CAIRNCROSS WASTE MANAGEMENT FACILITY EXPANSION

Response to Submissions – SSD 13_5792

11 DECEMBER 2018

Response to Submissions

Figure 6-8: Stage 2 and Stage 3 Boundaries (typical cross section)

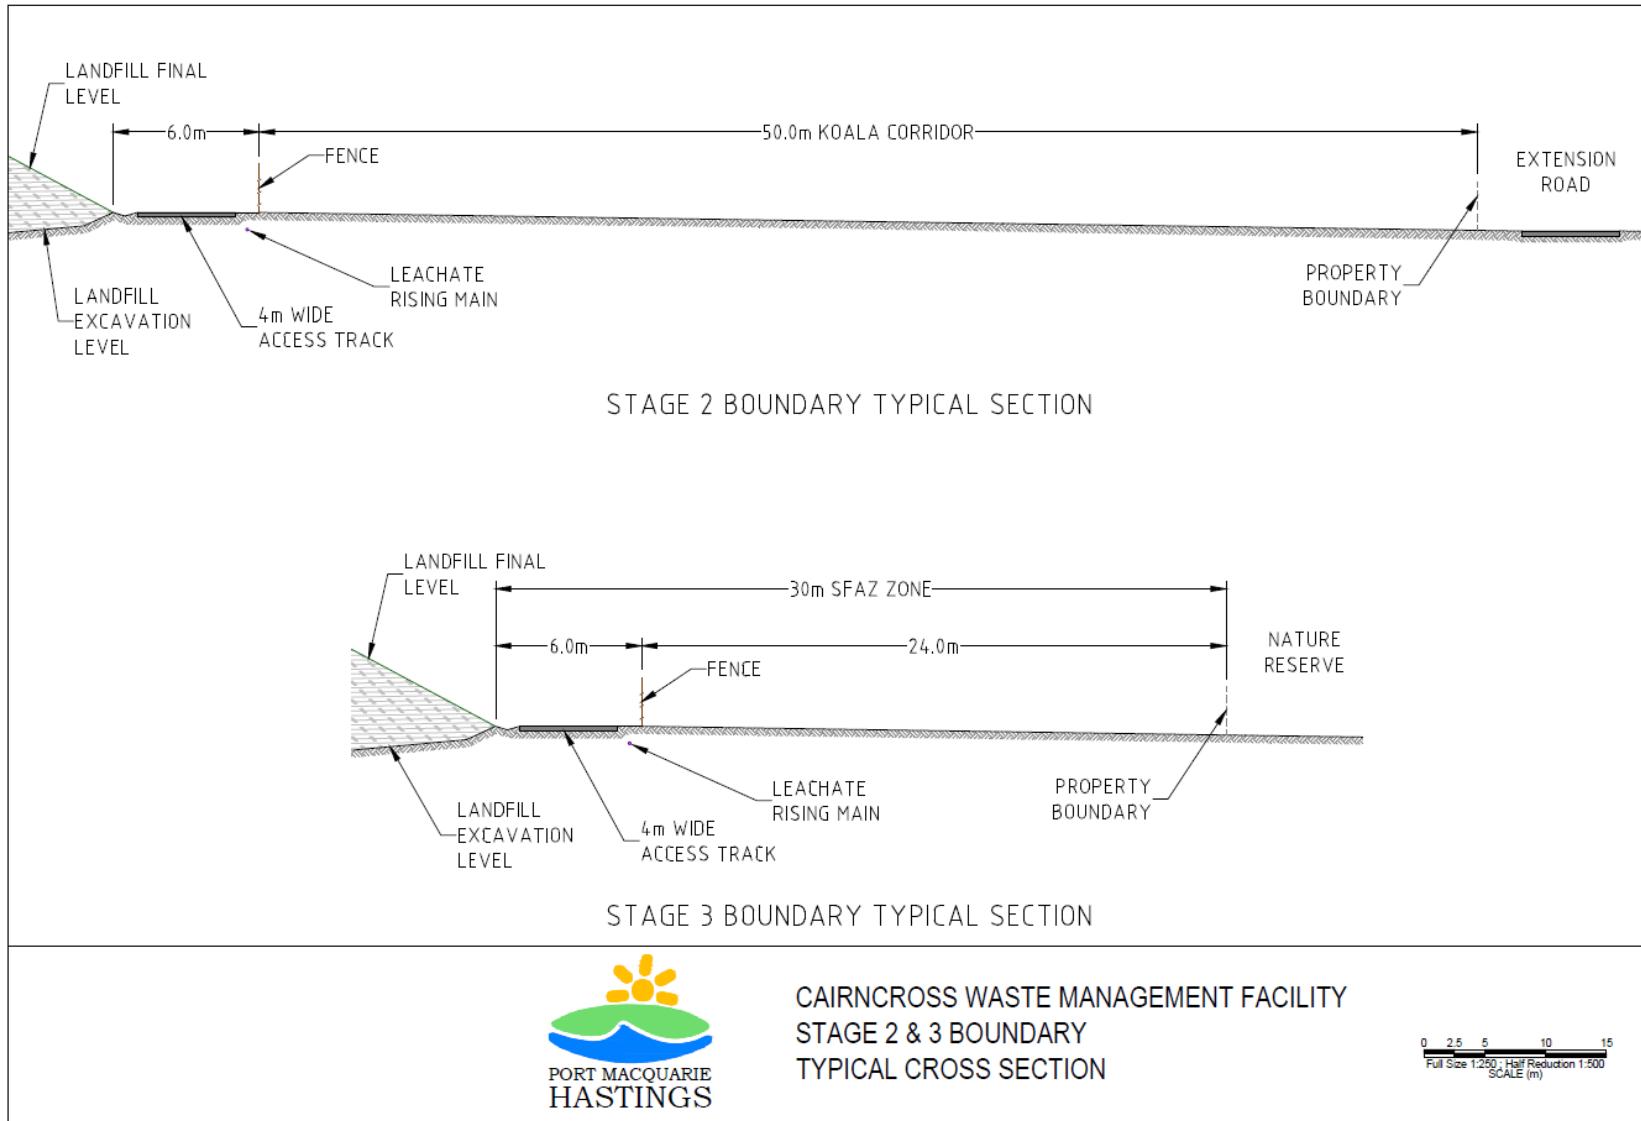
<p>The Bushfire Assessment states a 30m wide SFAZ will be provided and maintained along the south- eastern boundary with the adjoining NR as mapped in Figure 12 of the EIS. An existing fire trail will be upgraded and maintained to provide</p>	<p>Section 6 of this RtS summarises amendments made to the Proposal in response to submissions received and/or as a result of design progressions. Amendments have been made to the concept design for the Amended Proposal to</p>	<p>Section 6 of this RtS – Amended Proposal</p>

Topic	Issue	Response	Reference
	<p>an all-weather access having a width of 4m within a 6m corridor kept clear of shrubs and grasses.</p> <p>The Bushfire Assessment also identifies that an all-weather access along the southern boundary of the subject land (i.e. that adjoins the State Forest) will be provided. There is an existing fire trail (identified as Extension Road) along the southern boundary but it is not clear if this is on the subject site (as shown in Figure 12) as it appears to be on the adjoining State Forest land according to information available to the OEH. This should be confirmed by survey.</p> <p>For the south-eastern boundary, a chain wire fence is proposed along the boundary to the NR with the fire trail adjacent to the fence. The NPWS has advised it does not want to be in a position where it would be required to clear vegetation within the NR to either protect fence assets or defend the waste facility. The NPWS preference is for the SFAZ and associated fencing and fire trails to be wholly located on the waste facility site such that there is no requirement for clearing of the NR.</p> <p><u>OEH Recommendations</u></p> <p>4. The Strategic Fire Advantage Zone in the vicinity of the south-eastern boundary of the subject land, including any fencing or fire trails, should be established outside the 50m wide vegetated buffer to the Rawdon Creek Nature Reserve, in consultation with the National Parks and Wildlife Service.</p> <p>5. Fencing and fire trail access in the vicinity of the southern boundary of the subject land should be located outside the 50 m wide area to be retained and managed as a koala connectivity corridor.</p>	<p>more clearly show the koala corridor and associated infrastructure, including the perimeter fire access.</p> <p>As shown within Figure 6-6 of this RtS, external fire trails are located along the external perimeter of the Amended Proposal Site. This external perimeter runs outside of the koala corridor and Nature Reserve (i.e. extension road), which links to the internal fire access network between the SFAZ and koala corridor. The existing fire trail to the south is not located within the Amended Proposal Site, but rather is on the adjoining State Forest land. The existing external fire trails do not form part of the Amended Proposal.</p> <p>The internal fire trail access road network and associated fencing is located inside of the koala corridor and SFAZ to the south of Stages 2 and 3 of the Amended Proposal (refer to Figure 6-8).</p>

No changes to the above bushfire mitigation measures are proposed as part of the Amended Proposal. Notwithstanding this, design refinement and site optimisation has led to a clearer delineation of the above elements within the Amended Proposal concept designs (as shown in Figure 6-1 to Figure 6-6) to ensure appropriate incorporation of the proposed bushfire mitigation measures. This has resulted in a minor change to the layout of Stage 37 to adequately incorporate the proposed SFAZ (refer to Figure 6-8), as well as other minor layout changes across the Amended Proposal Site.

Figure 6-9 Proposed landfill base typical cross section

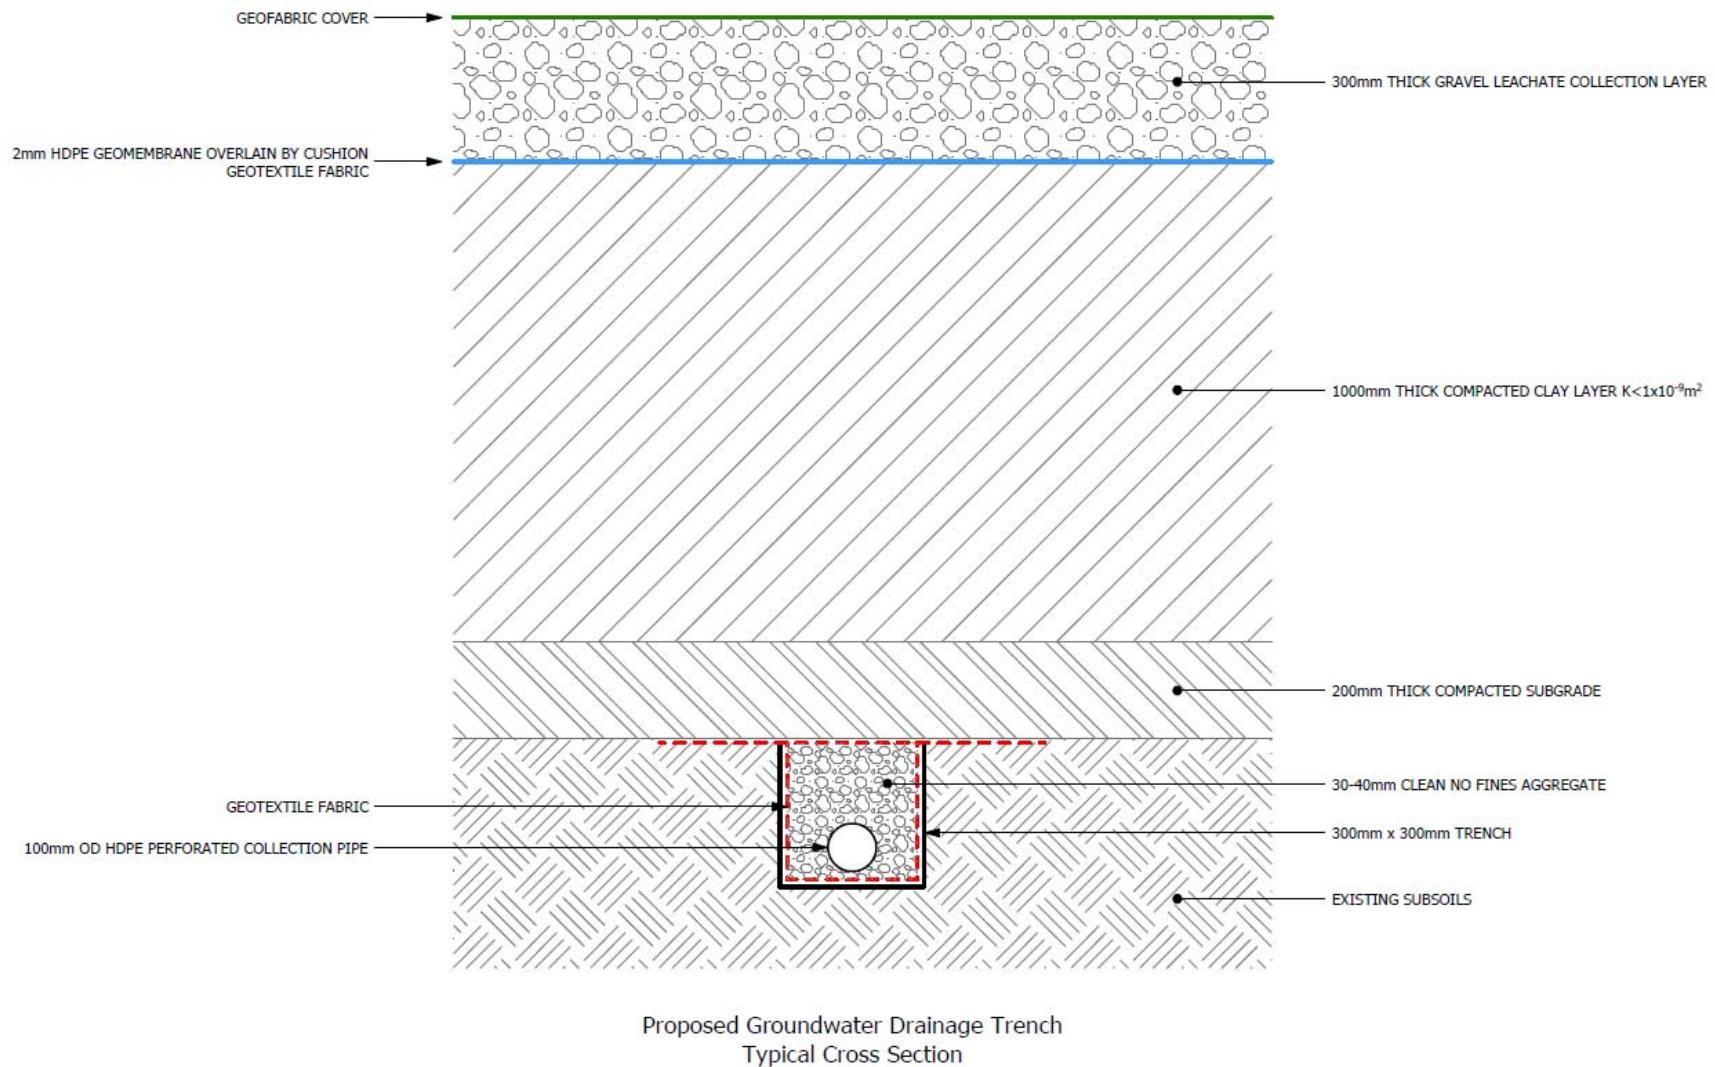
Groundwater levels	<p>As stated in the EIS, the proposed excavations for stages 1, 2 and 3, particularly those for stages 1 and 2, are expected to intercept groundwater during above-average groundwater levels. According to the EIS (Page 48) "In order to avoid any</p>	<p>As noted in Section 6.3.3 of the EIS the Cairncross WMF is currently subject to EPL 11189. PMHC will seek a modification to this EPL, where required, to incorporate the construction and operation of the Amended Proposal. Requirements within the EPL will be discussed and agreed with the EPA during the modification process.</p>	<p>Section 6.3.3 of the EIS</p>

The purpose of the collection/drainage layer would be to manage groundwater inflow rates and resulting hydrostatic upward pressure under the predicted maximum potentiometric head conditions, while allowing for enough capacity to prevent clogging of the system. The most likely design option for the collection/drainage layer is through the installation of collection trenches containing a high-permeability granular material and perforated pipework (Figure 6-9). A herringbone pattern of trenches would use gravity to drain the groundwater to a main header pipe and sump system for extraction.

The suitability of the collection pipe design will be confirmed within the detailed design phase. An alternate option, using geo-composite drainage nets is also considered suitable (described in Appendix D of this RtS). In addition, a geotextile layer can be placed between the base of the landfill and underside of the clay capping layer if the groundwater properties are found to be likely to result in clogging of the proposed system.

Figure 7-1: Elevation of Maximum Groundwater Heads above landfill floor for Amended Proposal Site (no mitigation)

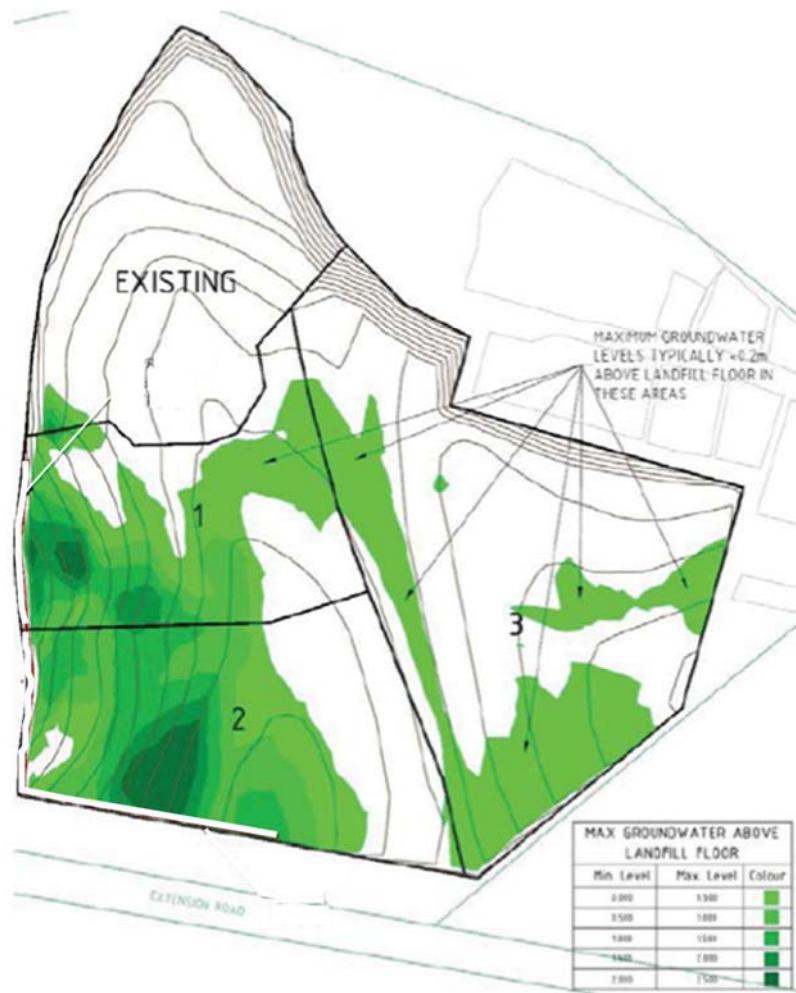
However, should above average groundwater heads occur (i.e. during an extended wet weather period), the groundwater table may intersect the floor of the landfill, likely resulting in groundwater inflow. The extent of this potential interception is shown in Figure 7-1.

As indicated by Figure 7-1, areas at risk of encountering groundwater interception during maximum piezometric conditions are shaded green. Areas shaded light-green above the maximum groundwater heads are likely to be generally <0.2 m above the floor level, and are therefore considered lower risk of groundwater interception. Areas of dark-green in the western area of Stage 1 and south of Stage 2 indicate that the maximum groundwater head may exceed the landfill floor elevation by up to 2 m. These areas represent topographically elevated areas sloping to the east.
